PARTS & SERVICE NEWS

REF NO.	AT99157
DATE	Nov. 1, 1999

SUBJECT: INTRODUCTION OF DUST PROOF TYPE T/C, T/M OIL SEAL, RETAINER ON WA700/800/900-1, 3

(2) Retainer with added muddy water weep holes

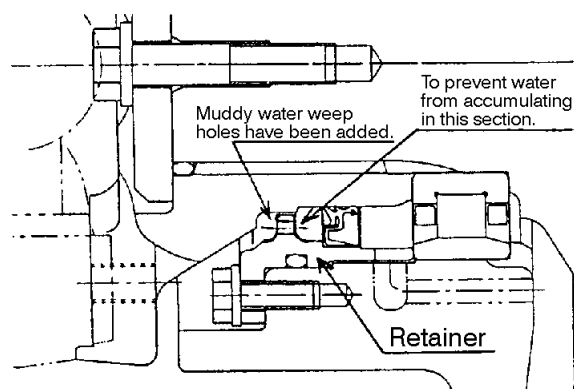
We have prepared new retainer with supplemented muddy water weep holes for use in the torque converter input shaft section.

Location where modification effected	Part numbers of the new and current retainer	Applicable machine models
Torque converter input shaft section	711-56-33331 (Muddy water weep holes have been added.) ø5 hole at 2 places ↑ 711-56-33330	WA800-1, -2, -3 WA900-1, -3 WD900-3 WA700-1, -3

- (2) Retainer with added muddy water weep holes
Replace the retainer referring to the Section "Disassembly and Assembly of Torque Converter" in the Chapter "Disassembly and Assembly" in the Shop Manual.

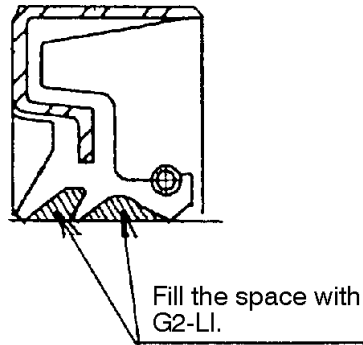
- (1) Oil seals equipped with duplex dust lips
 - 1) Replace the oil seals referring to the Section "Disassembly and Assembly of Torque Converter" and "Disassembly and Assembly of Transmission" in the Chapter "Disassembly and Assembly" in the Shop Manual.
 - 2) When installing the new oil seals, fill the space occurring among the dust lips and the oil lip with lithium grease G2-LI. (Refer to the illustration given below.)
